Lotus Elan M100 Service Bulletins
Series 1 and Series 2 1990 - 1996

SERVICE BULLETIN

TITLE: Replacement of headlamp flap 'J' links.

Headlamp Pod Raised

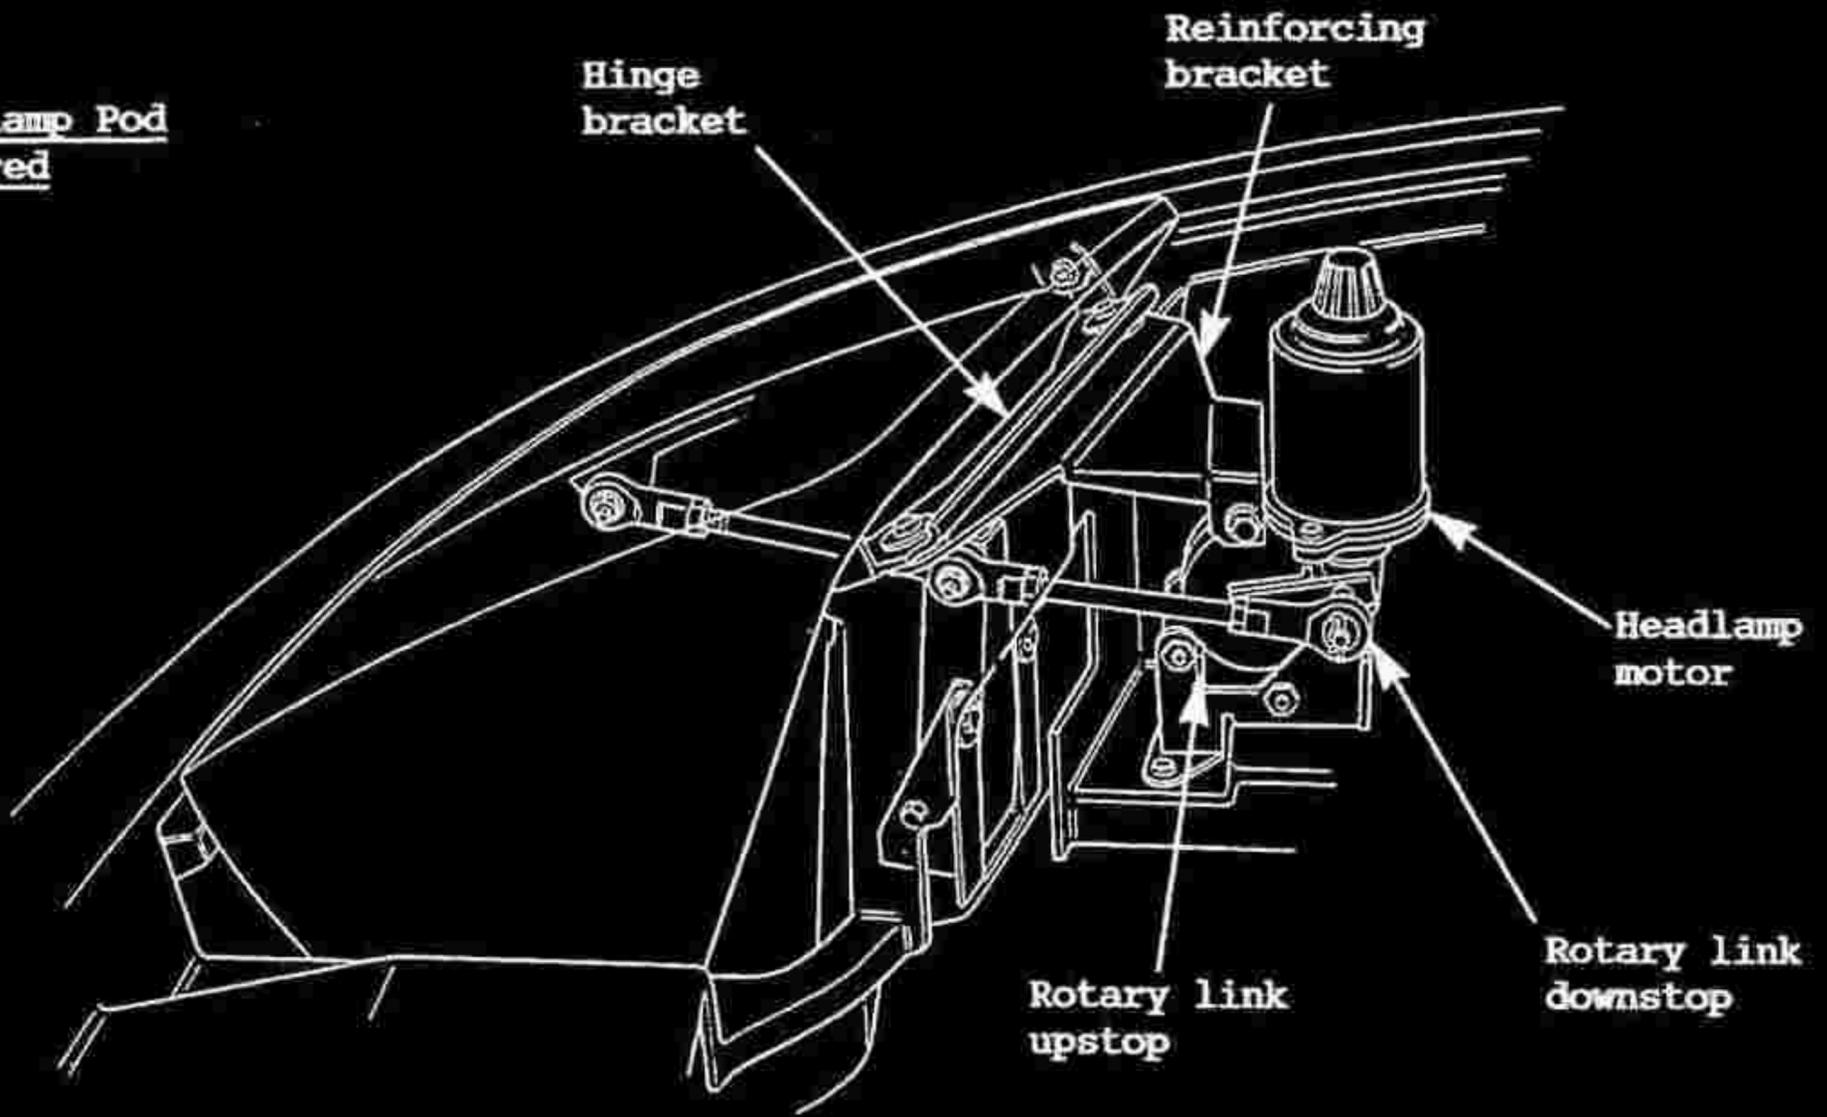
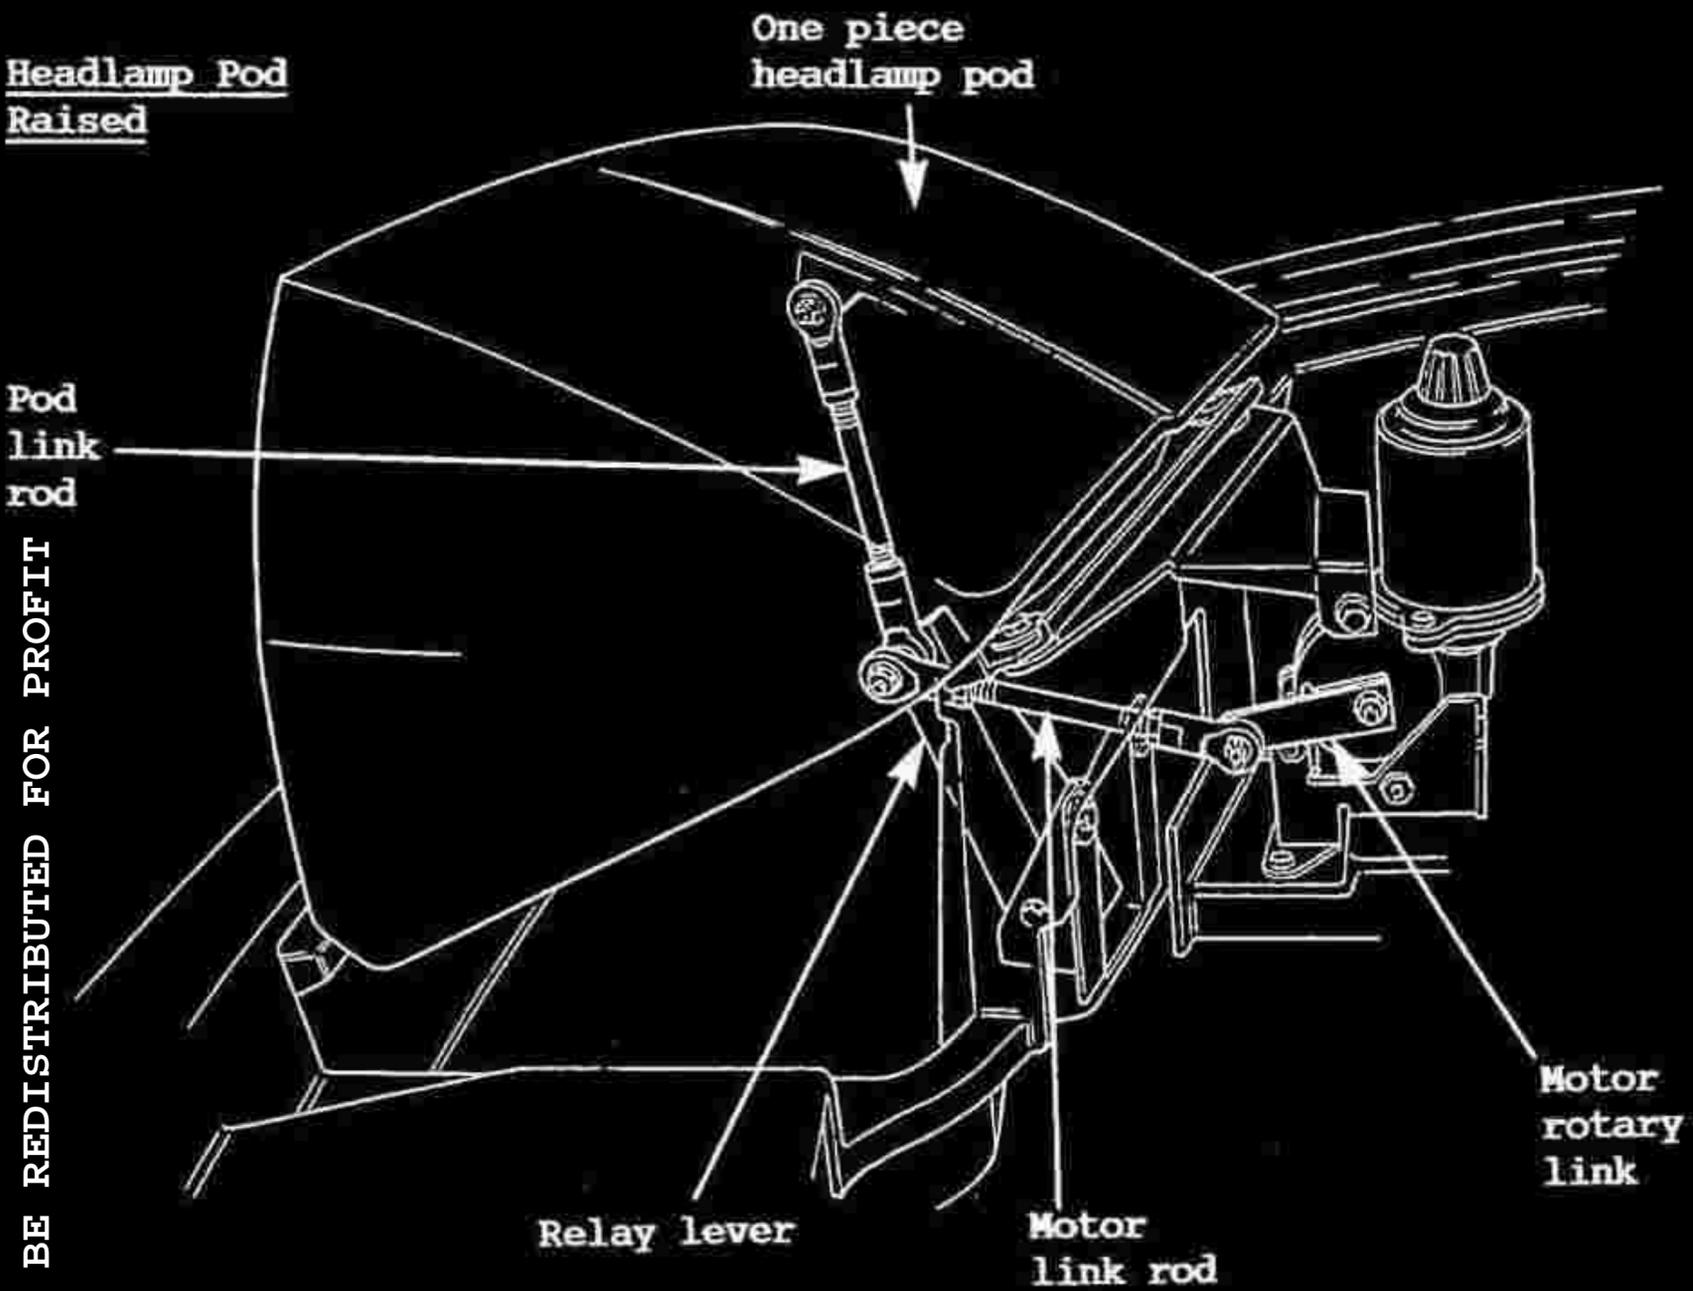
TITLE: Introduction of 'single pivot' headlamp mechanism. Revised fettling of right hand pod lower edge.

REASON: i) Simplified headlamp mechanism and adjustment procedure.
ii) Revised fettling to provide increased clearance between pod and PAS hose.

1. Pod Shutlines; To adjust the pod shut height and shutlines, slacken the two bolts securing the hinge bracket to the topshell, and add/delete slotted shim washers as necessary to achieve correct pod height and alignment. Position the pod to achieve a 5mm (approx) shut gap between the pod and topshell/bonnet.

2. Motor Link; Adjust the length of the link between motor and relay lever to 140 mm between ball joint centres, with an equal amount of thread showing at each end of the link. Tighten the locknuts, ensuring that the two ball joints are parallel to each other. This dimension will ensure that the linkage goes just over centre with the pod raised, to provide a rigid prop.

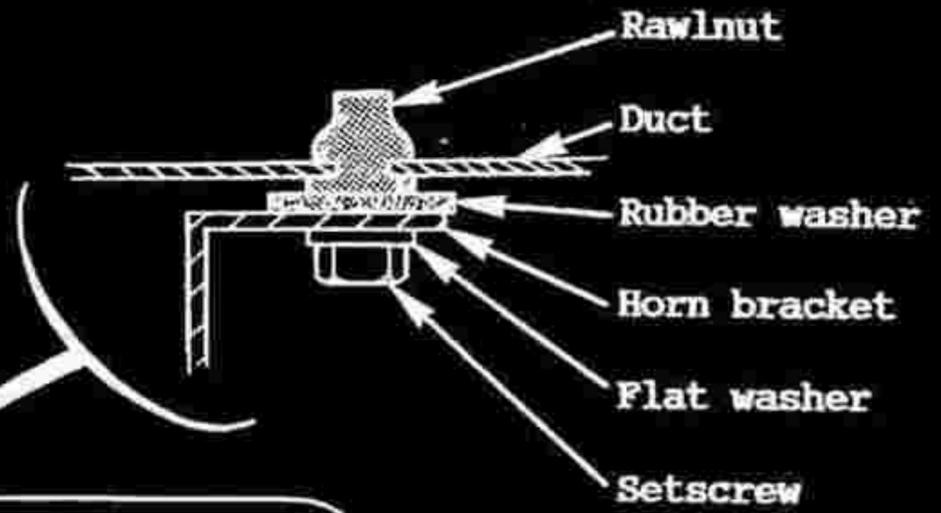
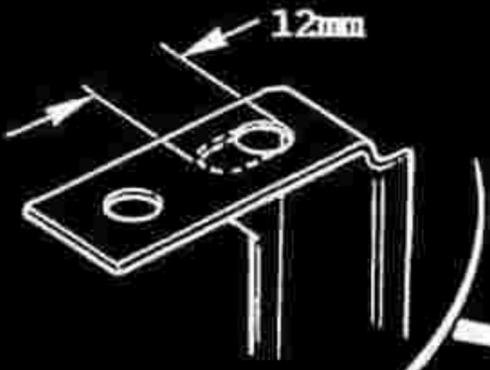
ACTION: At the next opportunity (i.e. next time the car is on the dealer premises), on all '90 model year cars prior to VIN L 6333 (refer to S/B 1990/31), replace the two existing horn brackets with the new one-piece design.

1. Remove the right hand front wheelarch liner.
2. Release each horn from its mounting bracket, and remove the two brackets from the oil cooler duct.

3. Using a 13mm diameter drill, open up the two horn bracket fixing holes in the top of the duct, and insert an M6 Rawlnut (A075W6140F) into each of the holes.

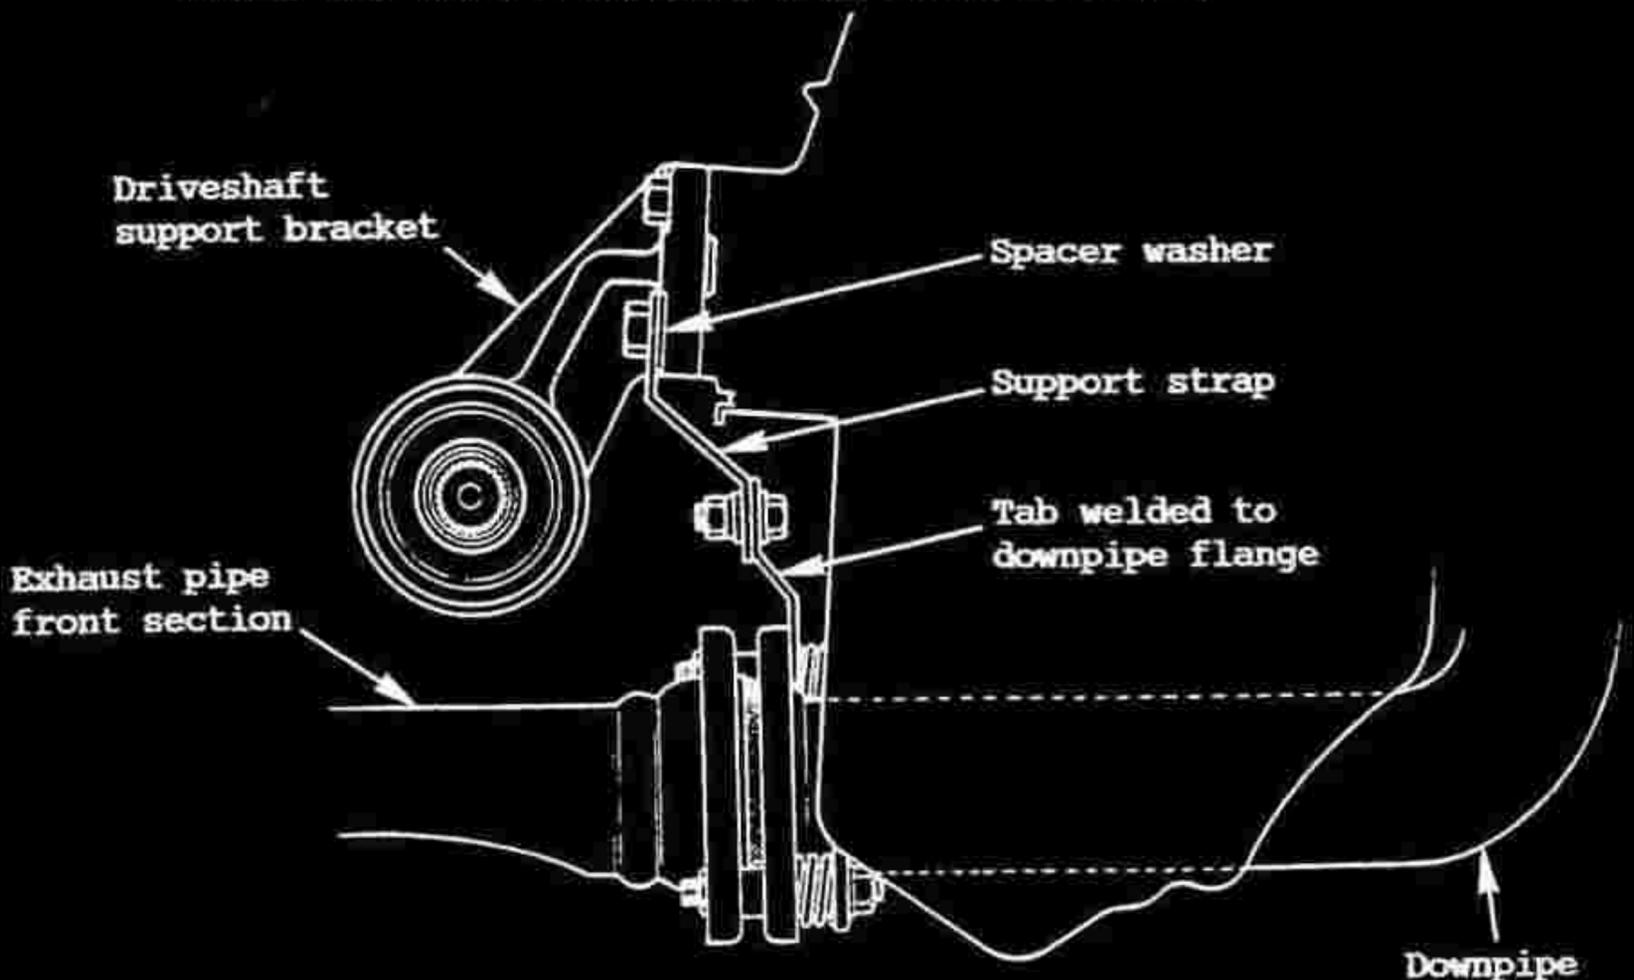
Parts Required	Part No.	Qty
Downpipe	C100S0023F	1
Support Strap	A100S0053F	1
Setscrew, M8 x 25, strap/downpipe	A075W1039Z	1
Washer, flat, M8, strap/downpipe	A075W4020Z	2
Washer, spring, strap/downpipe	A075W4036Z	1
Nut, M8, strap/downpipe	A075W3021Z	1
Spacer Washer, M10, strap/engine	A075W4024Z	1

Fit the strap as shown in the diagram, using the lower of the two M10 bolts securing the driveshaft support bracket to the cylinder block. Note that because the support bracket fixing hole has a slight counterbore, it is most important to fit the M10 spacer washer between the strap and driveshaft bracket.

Relay stations viewed from beneath

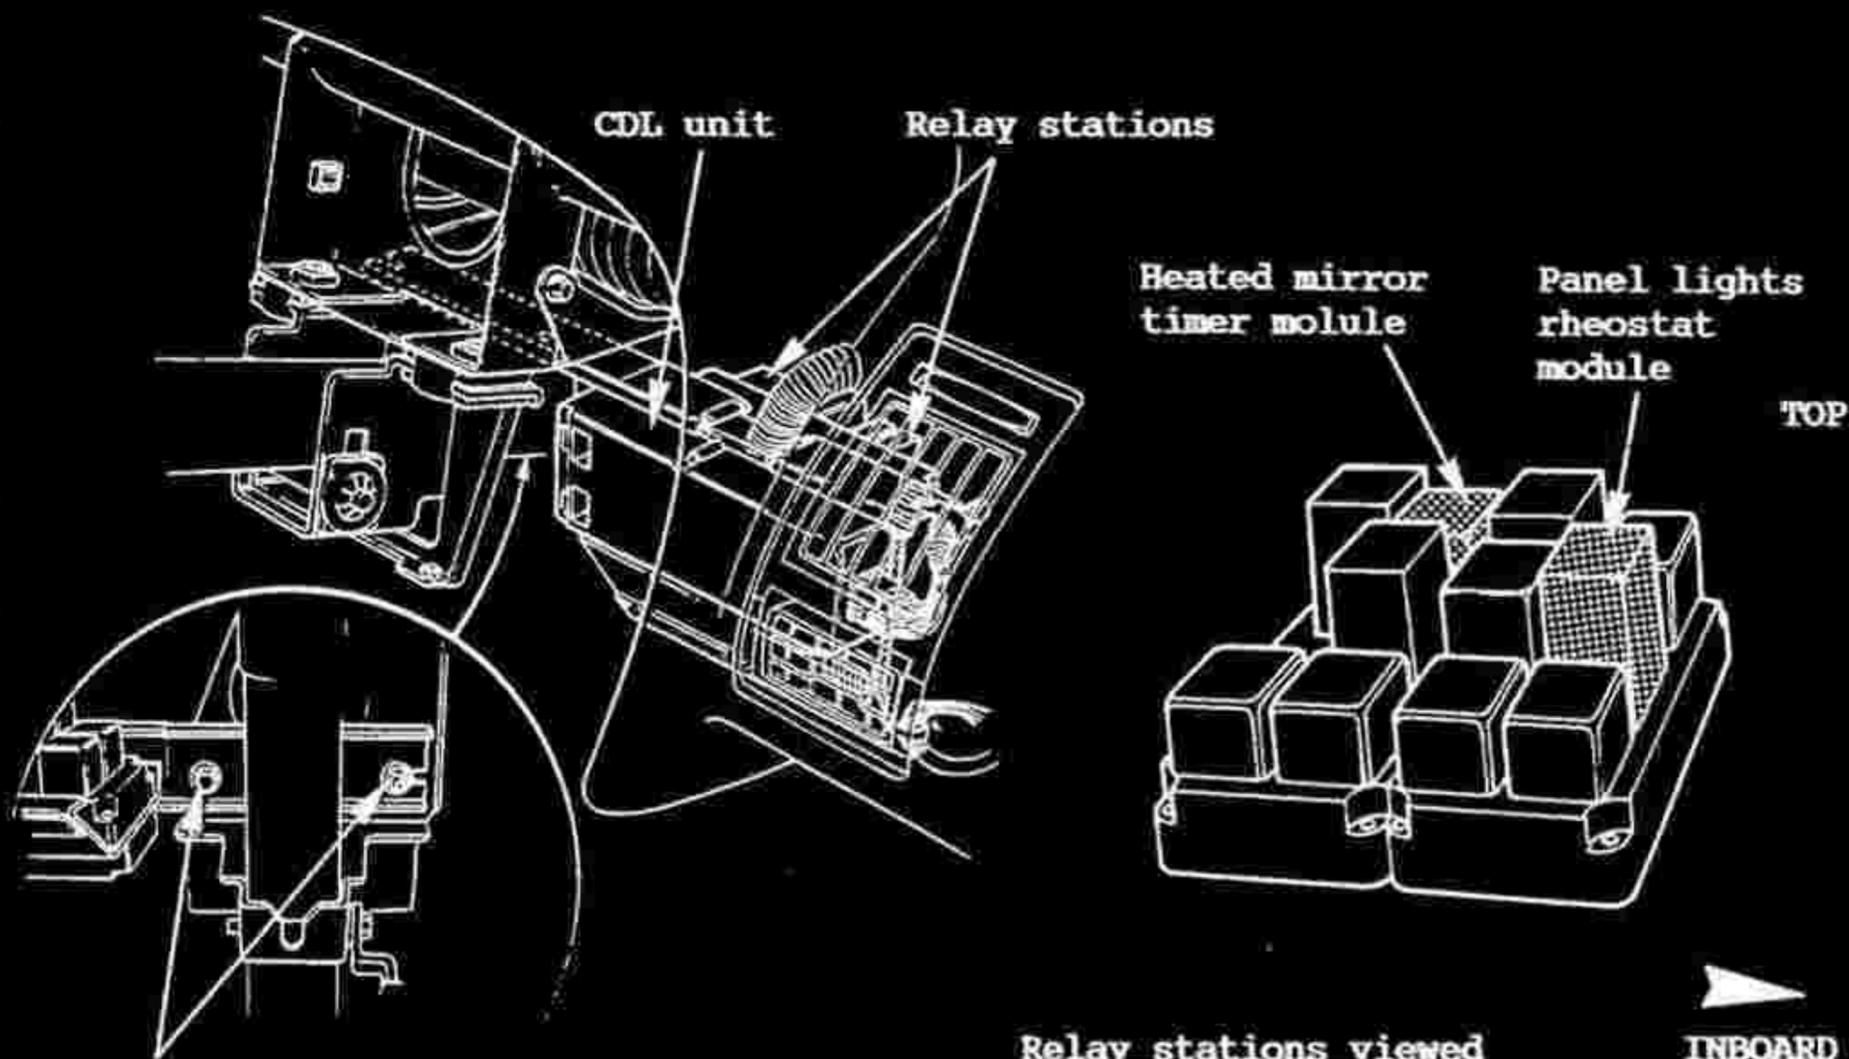
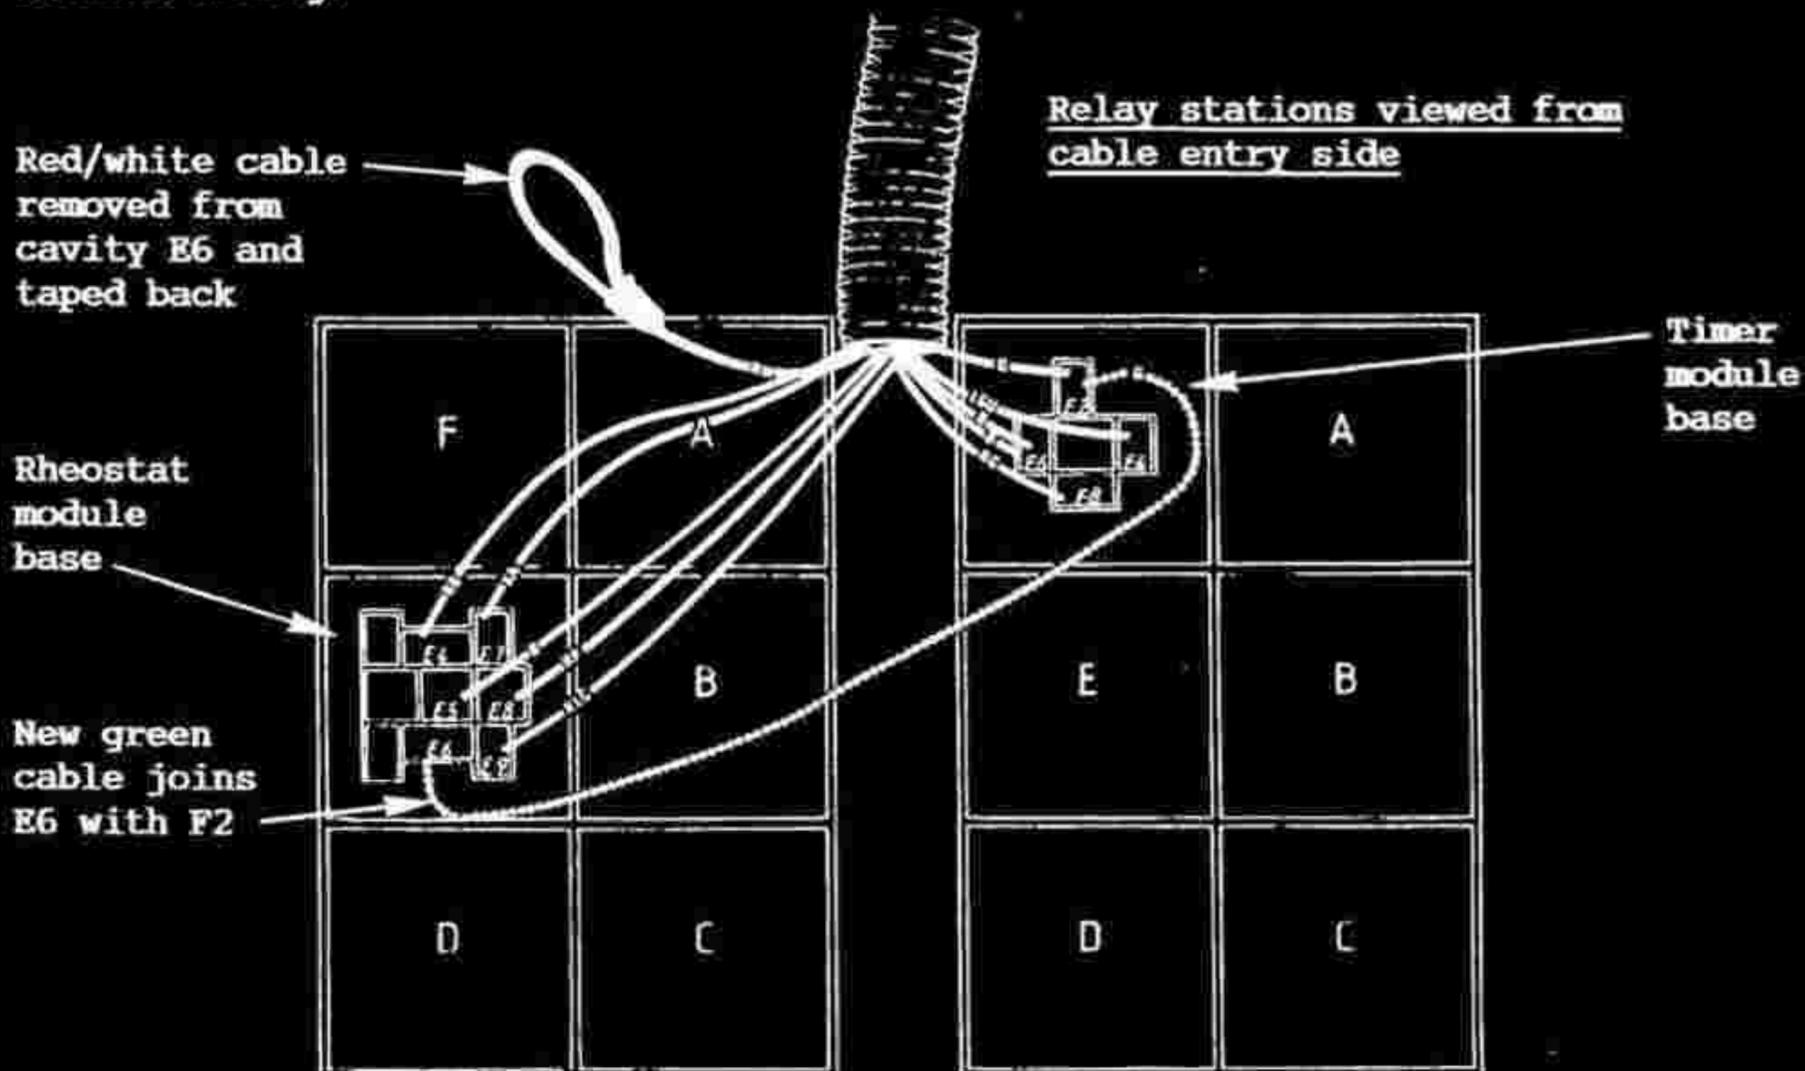
TITLE: Change to switching logic of panel lights.

3. Use a jewellers screwdriver or similar to remove the red/white cable from cavity E6 of the rheostat module base. Insulate and tape back.
4. Remove the green cable from cavity F2 of the heated mirror timer module base and cut off the terminal. Add 250mm of 0.5mm² green cable, and terminate the pair of cables with the longer legged spade terminal supplied in the kit. Refit the terminal into cavity F2 of the timer module base.

6. Refit the relay stations to the mounting bracket, and insert the relays. Refit the bracket assembly to the steering column brace.
7. In the passenger footwell, replace the existing 3A fuse in slot 19 of fusebox A (heated mirror timer), with the new 7.5A fuse.
